January 14, 2025

**Re: Samaritan Reservoir and Pump Station (PR#158-2025)
City of Newport (PWS ID#00566)
Conditional Approval**

Figure 1: Water Line-Sewer Line Separation

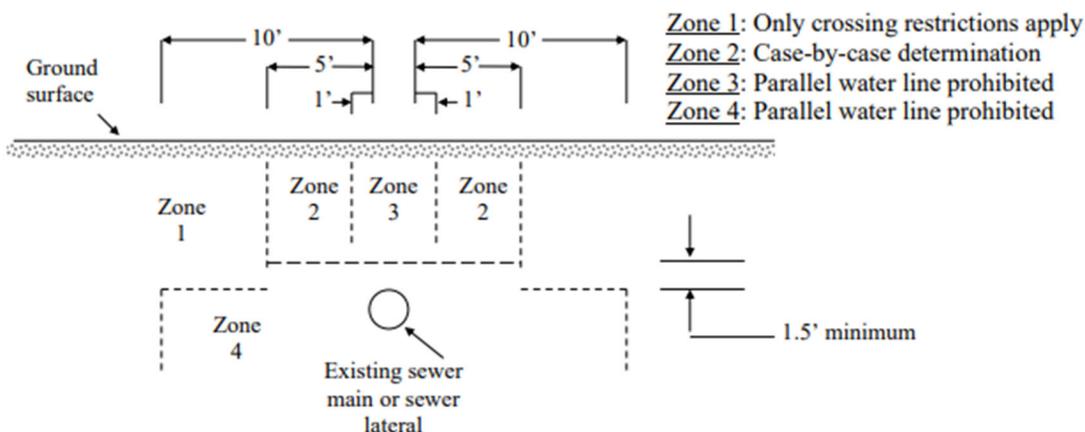
- In situations involving a water line parallel to a sewer main or sewer lateral, the separation between the two shall be as indicated in Figure 1. The proposed waterline and existing sewer main at approximately STA 17+73 appear to be in Zone 4 as drawn. A 10-foot separation must be maintained during construction in this section of parallel lines due to their relative elevations.
